MARSTON COURT SUBDIVISION

APPLICATION NUMBER 3 DATE June 17, 2021

DETAIL SITE PLAN

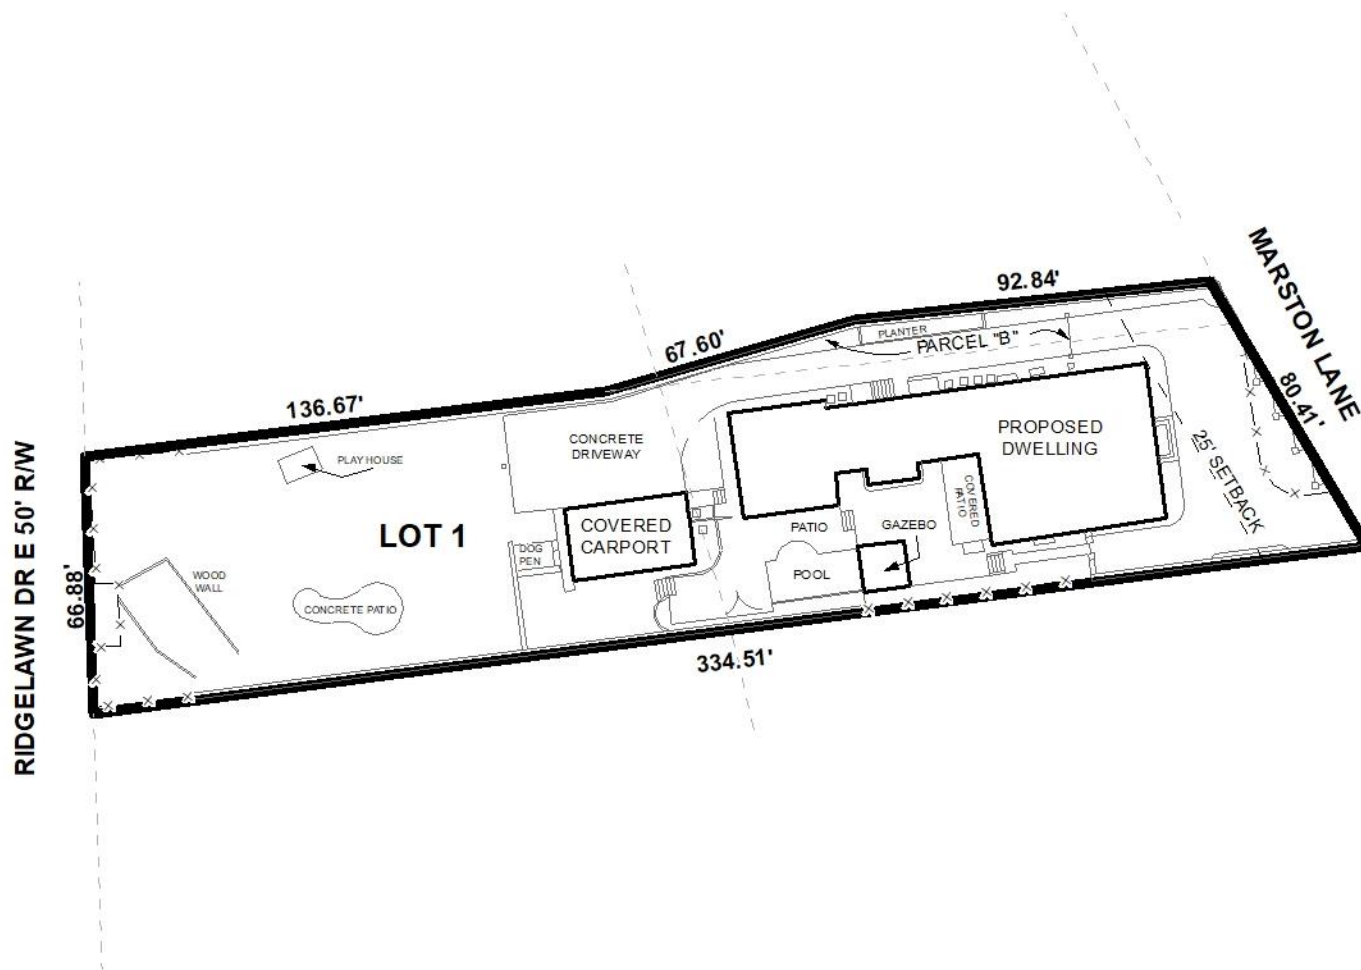
Marston Lane. Previous subdivision of the site required an additional 7.5' of right-of-way dedication along Marston Lane, thus no additional dedication should be required; however, the plat should depict the previously required right-of-way dedication.

The 25' minimum building setback line is illustrated along Marston Lane, but not along Ridgelawn Drive East. If approved, the plat should be revised to illustrate a 25' minimum building setback line along each street front, per Section V.D.9. of the Subdivision Regulations.

Finally, a 10' drainage easement not illustrated on the preliminary plat was recorded along the rear property line of Lot 6 of Whiteford Square Subdivision, toward the center of the proposed lot. The existing dwelling, built in 1986 according to the County Revenue Commission, encroaches on this easement, but Staff did not find any evidence that the easement or any portion of the easement was vacated. Staff did determine that the easement does not contain any city infrastructure, thus indicating private drainage is being conveyed in the easement, but the applicant is nevertheless encouraged to vacate the easement; or, if the easement or any portion thereof has been vacated, the applicant should provide proof of the vacation to the Planning Commission. Either vacation, or proof of vacation of the easement should be required prior to recording of the Final Plat, if approved.

- 1) Revision of the plat to illustrate the previously required 7.5' right-of-way dedication along Marston Lane;
- 2) Revision of the plat to illustrate the 25' minimum building setback line along each street front;

- 3) Vacation, or proof of previous vacation submitted to the Planning Commission of the 10' draining easement, prior to the recording of the Final Plat;
